RENESAS TECHNICAL UPDATE

Product Category	MPU & MCU		Document No.	TN-16C-A208A/E	Rev.	1.00
Title	Errata to R32C/111 Group Hardware Manual No. 3		Information Category	Technical Notification		
Applicable Product	R32C/111 Group	Lot No.	Reference Document	R32C/111 Group Hardware Manual Rev. 1.10 (REJ09B0424-0110)

This document describes corrections to the R32C/111 Group Hardware Manual, Rev. 1.10.
The corrections are indicated in red in the list below.

Figure 8.1 Clock Generation Circuitry

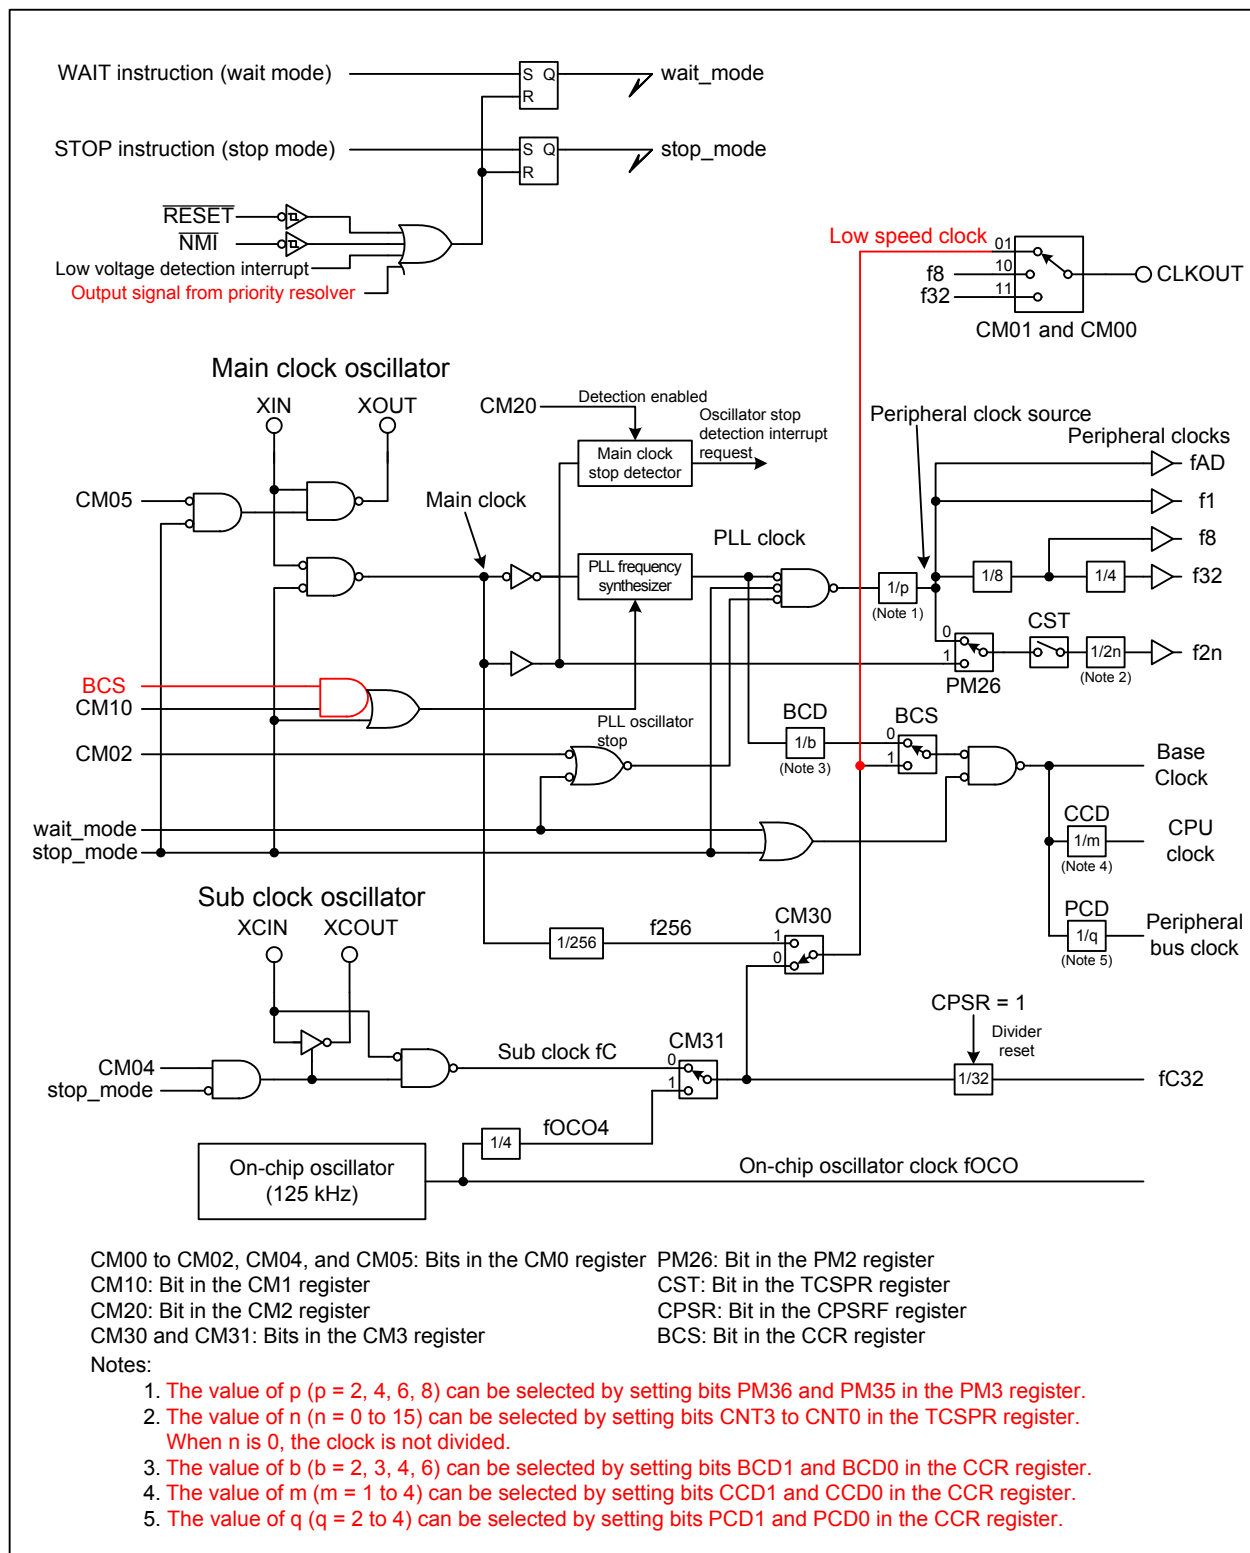
•Page 76 of 493, Figure 8.1 is corrected as follows:

Figure 9.14 ALE Signal and Address Bus/Data Bus

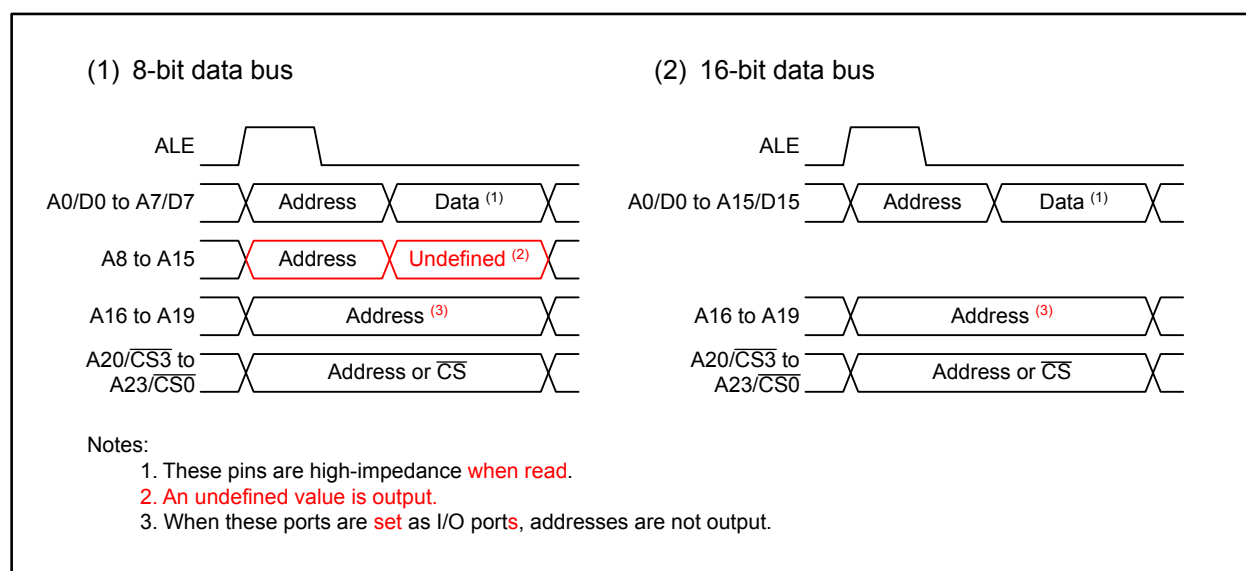
- Page 123 of 493, Figure 9.14 is corrected as follows:

Figure 11.8 Priority Resolver

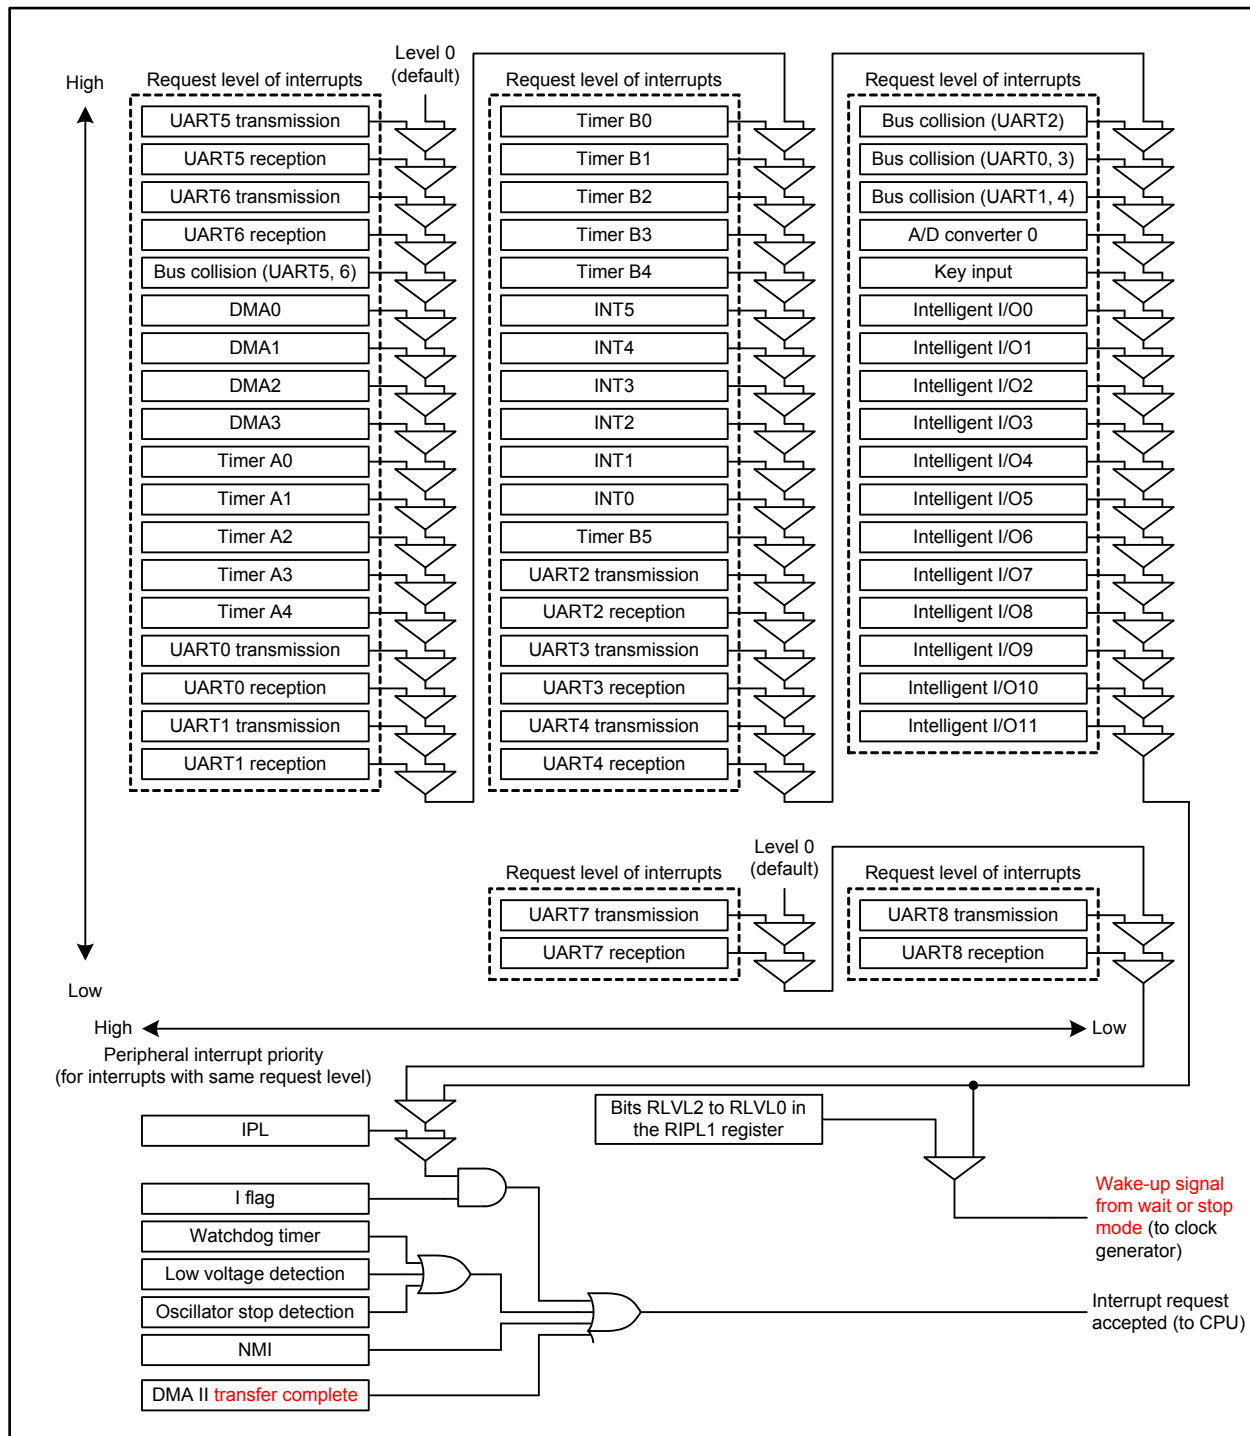
•Page 150 of 493, Figure 11.8 is corrected as follows:

(Description "Bits RLVL2 to RLVL0 in the RIPL2 register" and associated signal lines are deleted from Figure 11.8)

Figure 16.2 Timer B Configuration

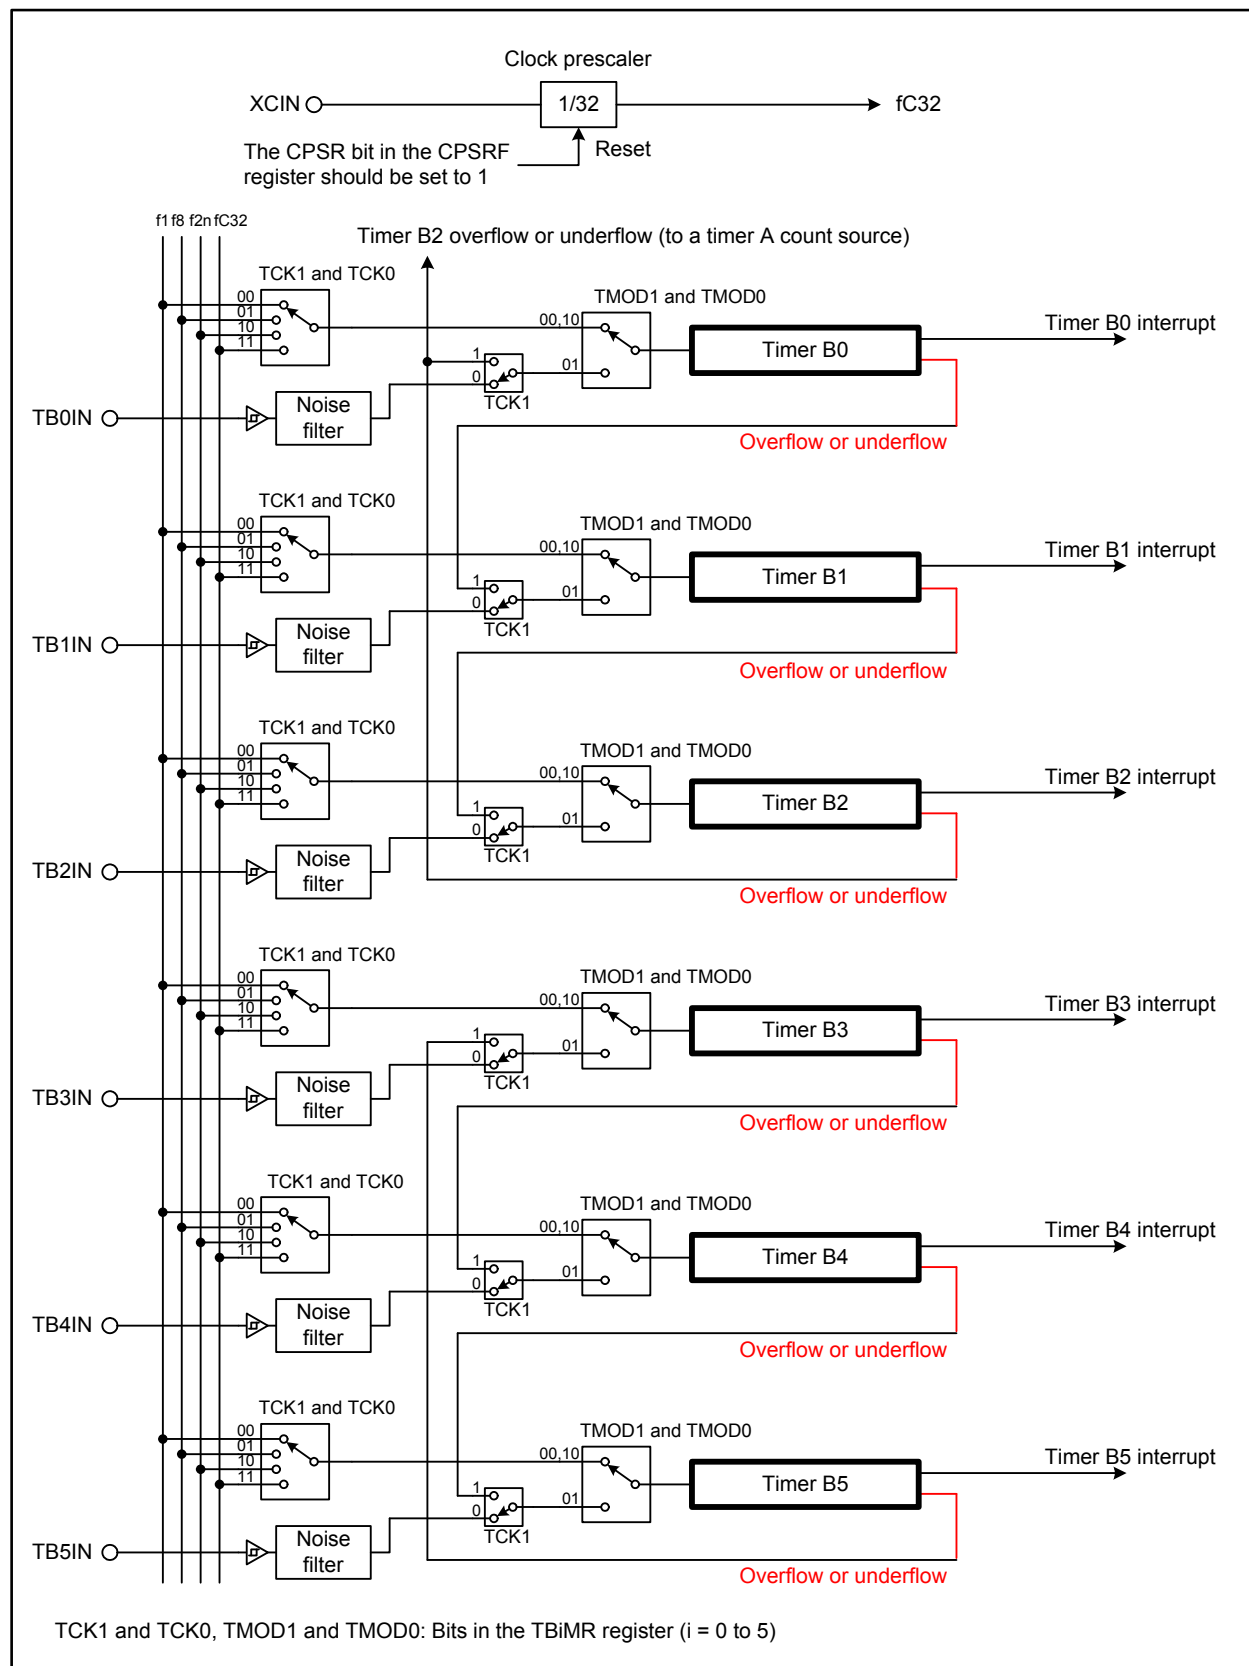
•Page 189 of 493, Figure 16.2 is corrected as follows:

Figure 21.1 CRC Calculator Block Diagram

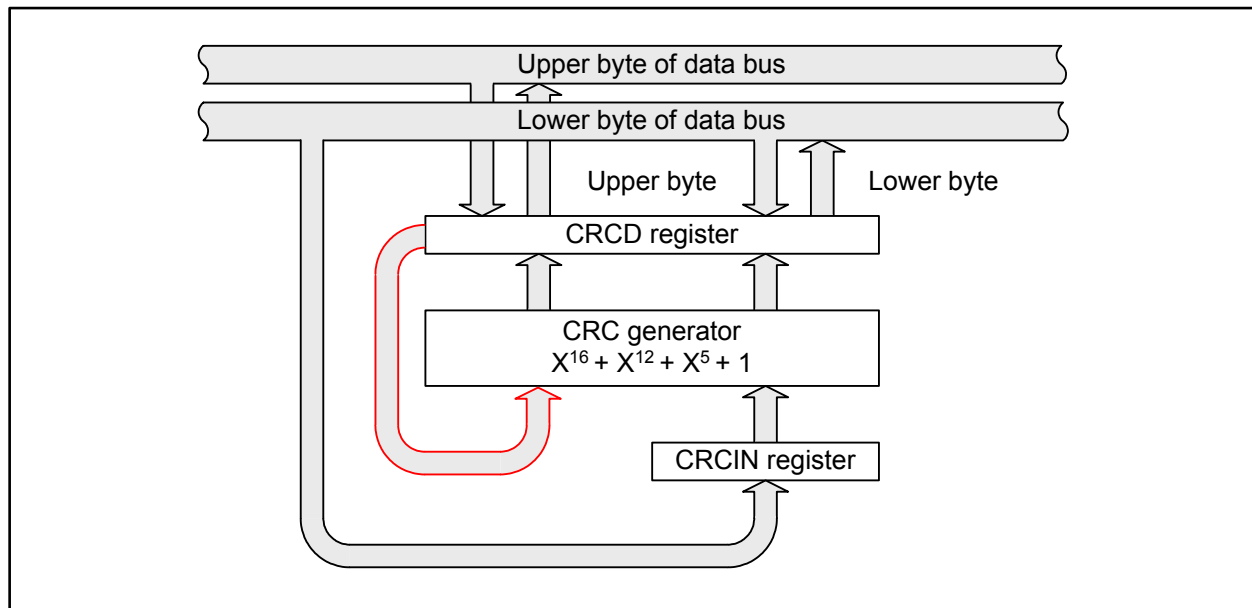
- Page 315 of 493, Figure 21.1 is corrected as follows:

Figure 24.1 Typical I/O Pin Block Diagram (i = 0 to 10; J = 0 to 7)

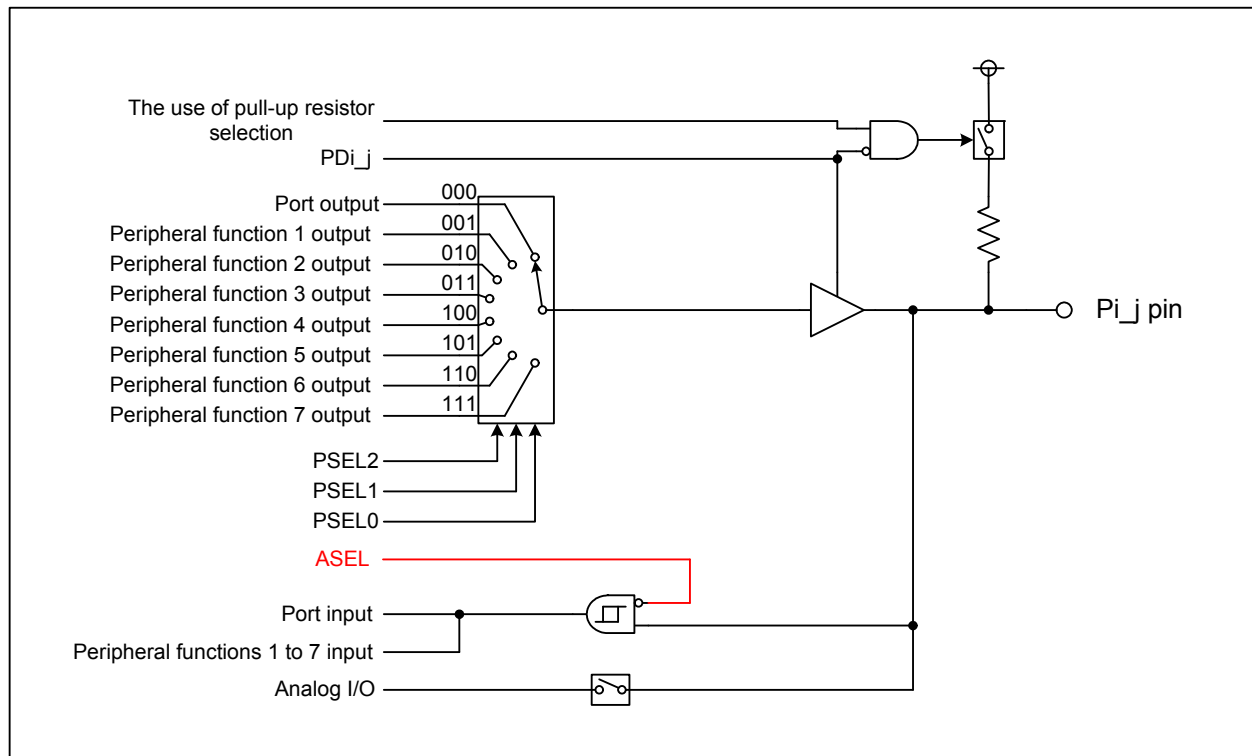
- Page 369 of 493, Figure 24.1 is corrected as follows (refer to TN_16C_A198A/E):

Figure 25.12 Read Timing

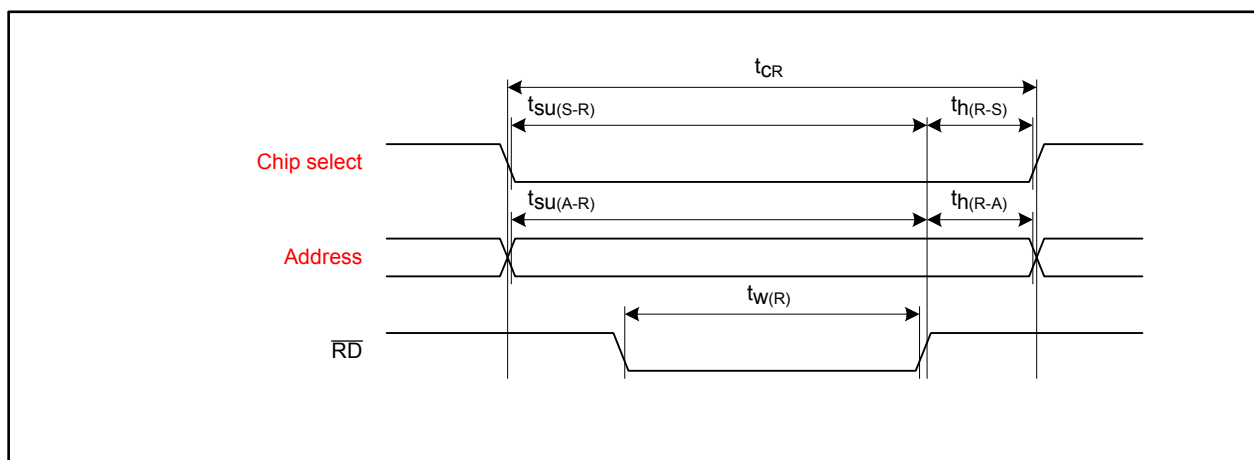
- Pages 410 and 412 of 493, descriptions in Figures 25.12 and 25.13 are corrected as follows:

Figure 26.5 Flash Memory CPU Rewrite Mode Timing

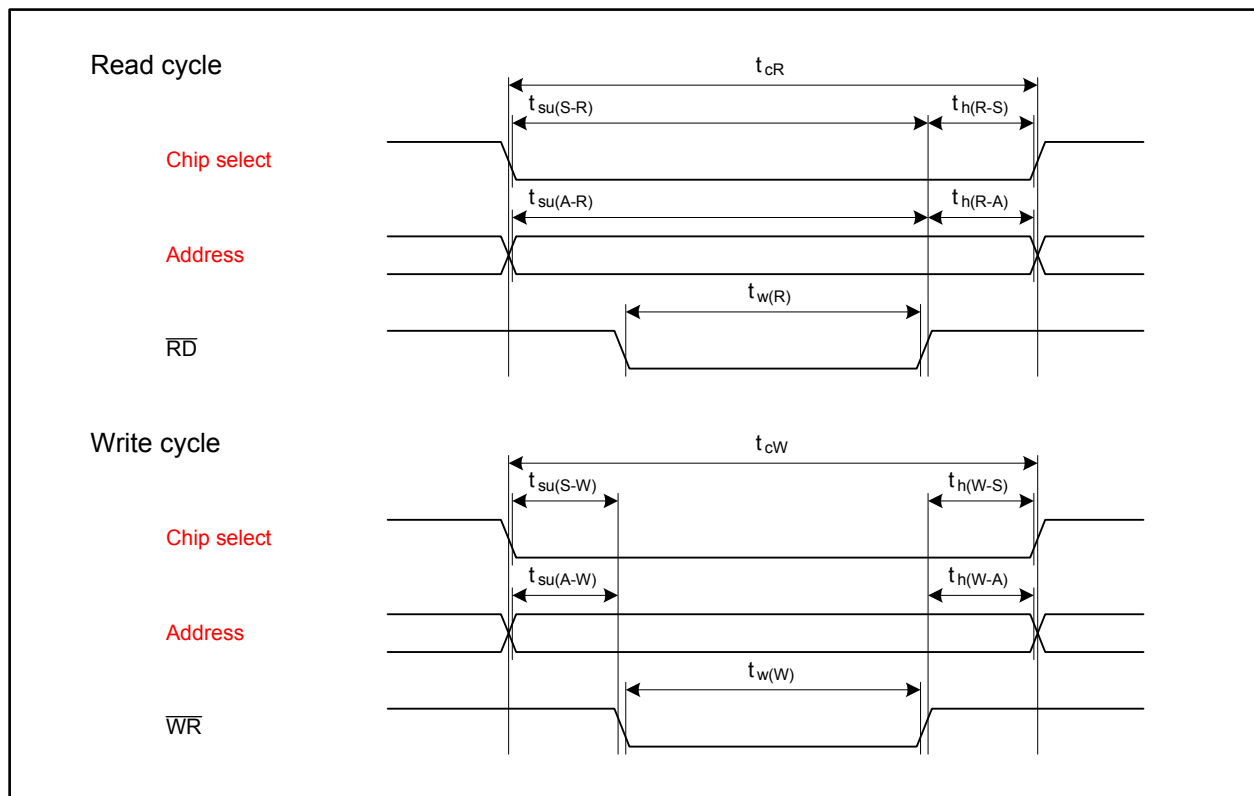
- Page 441 of 493, descriptions in Figure 26.5 are corrected as follows:
